**BEFORE THE
ZONING COMMISSION
FOR THE DISTRICT OF COLUMBIA**

Z.C. CASE NO. 22-28

**PREHEARING SUBMISSION
FOR DESIGN REVIEW
IN THE
M AND SOUTH CAPITOL STREETS SUB-AREA**

**1100 SOUTH CAPITOL STREET, SE
SQUARE 698, LOTS 814 & 817**

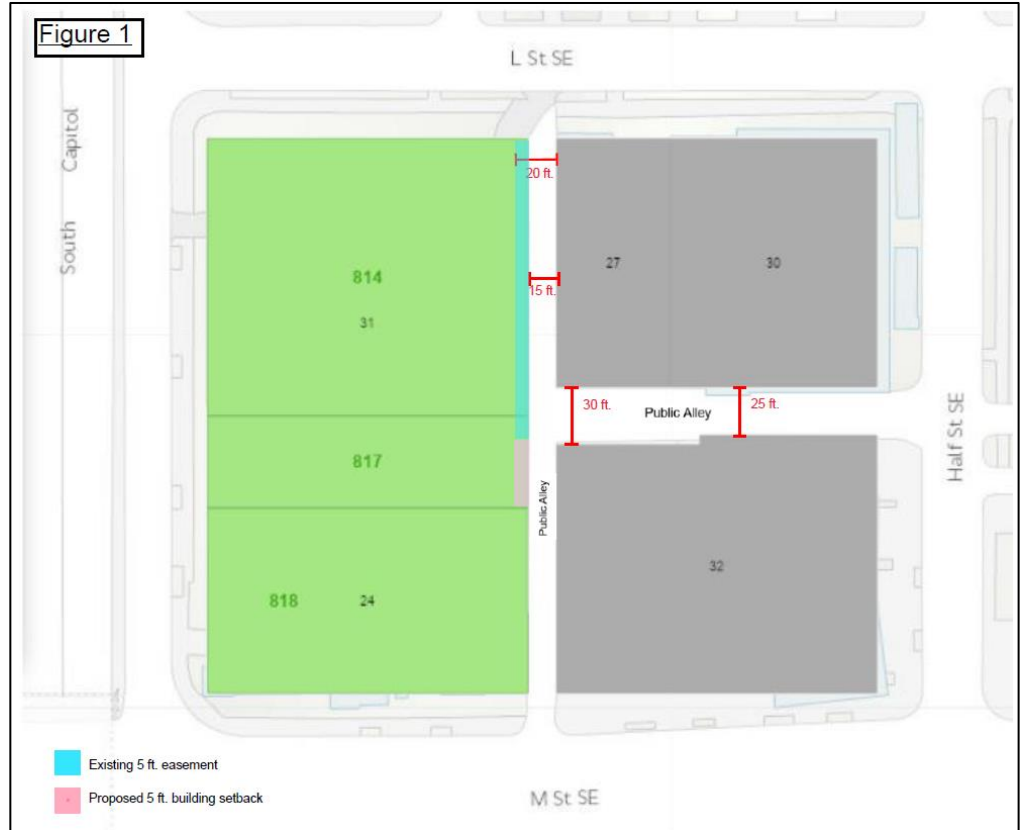
ANC Comment: The ANC asked for additional information on vehicular movements and uses within the alley and information on how the Applicant is addressing pedestrian safety within the alley. Members of the community expressed concerns with existing traffic in the alley and stated that the Project would exacerbate existing conditions.

Applicant's Response: As shown on Figure 1, the Property abuts a 15-foot wide north-south public alley in which all vehicular and loading activity will occur. The Property has an existing five-foot wide surface easement that runs along the northern portion of its east frontage and requires the building to be set back a minimum of five feet from the alley in this location. The Applicant proposes to extend the five-foot wide building setback to the southern portion of the Property's east frontage, such that the

As shown on Figure 1, the public alley system in Square 698 includes the 15-foot north-south alley (effectively 20 feet) abutting the Property that runs from L Street to M Street, and a 30-foot east-west alley that runs from the north-south alley and then narrows to 25 feet before it intersects with Half Street. Vehicles accessing the Property will do so by turning into the north-south alley from L Street to access the parking garage entrance, which has been placed at the closest point possible to L Street to minimize traffic within the alley.
